STAFF REPORT
(One-Step Final Plat)

CASE NUMBER: S/D 99-45 - NEWMAN UNIVERSITY ADDITION

LOCATION: Southwest corner of Sheridan and McCormick

VICINITY MAP

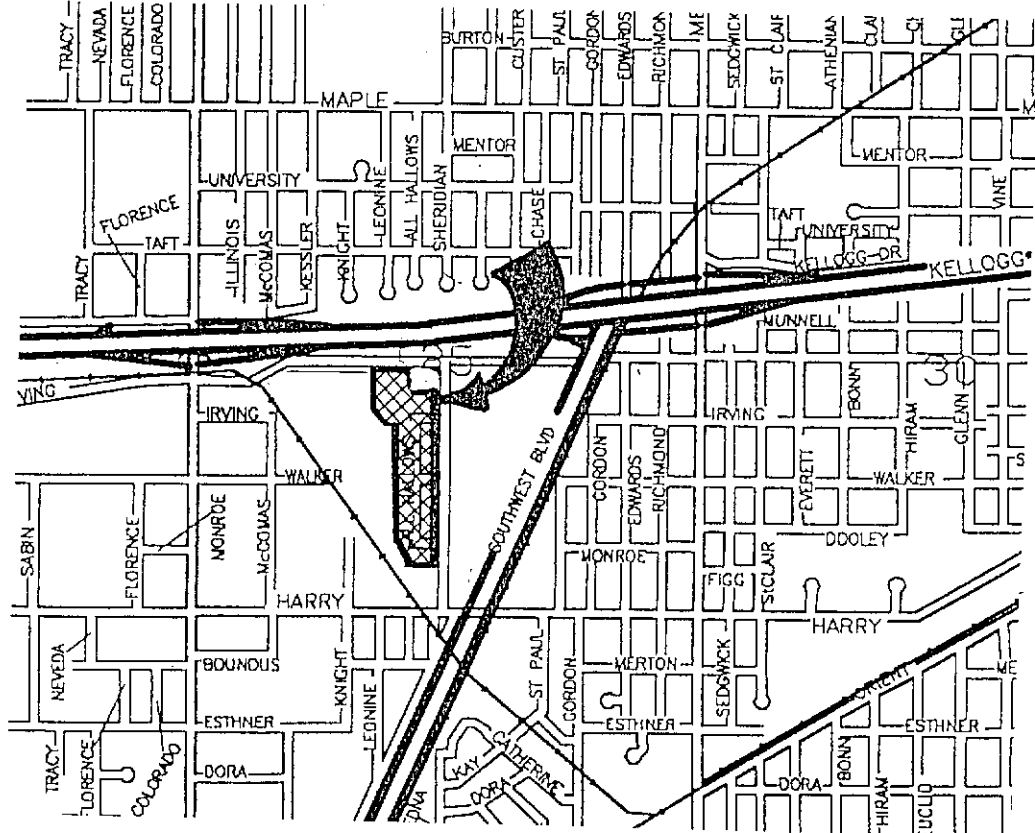
- C. **City Engineering** needs to comment on the status of the applicant's drainage plan.
- D. **Traffic Engineering** needs to comment on the access controls. The plat proposes two access openings along McCormick Avenue.

- E. The applicant shall submit a copy of the instrument which establishes the pipeline easements on the property, which verifies that the easements shown are sufficient and that utilities may be located adjacent to and within the easements.

- F. The applicant's agent shall determine any setback requirements for the pipelines by researching the text of the pipeline agreements. If a setback from the pipeline easements is provided for in the pipeline easement agreements, it shall be indicated on the face of the plat.
